**FINAL DRAINAGE REPORT**

**Lot 3A Northcrest Center Filing No 1A  
(My Garage @ Northcrest Center)**

**PCD File #PPR2412**

August 02, 2024

### Color Legend for IRF Calculation

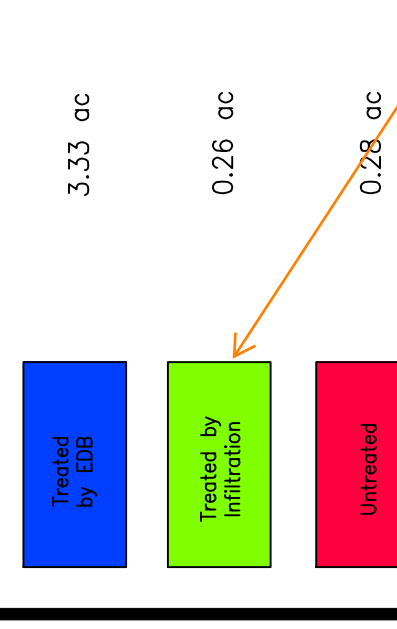
Clarify that this is "informal (non-PCM)" WQ treatment.
